Product Change Notification - SYST-07YG CW636

ERRATA - SAM G55 Series Family Silicon Errata and Data Sheet Clarifications

SAM G55 Series Family Silicon Errata and Data Sheet Clarification

8. Module: Transmitter Operations

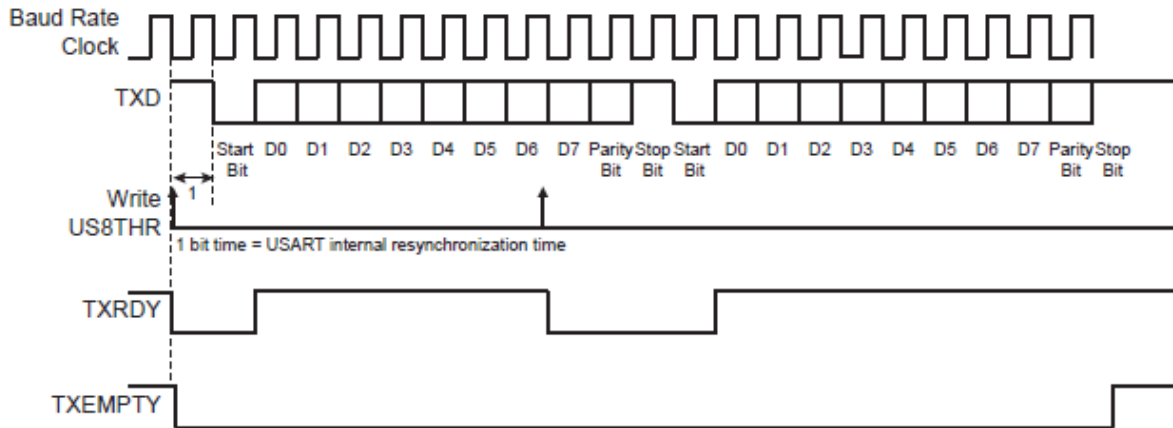
Figure 30-6 is incorrect. The corrected figure is as follows:
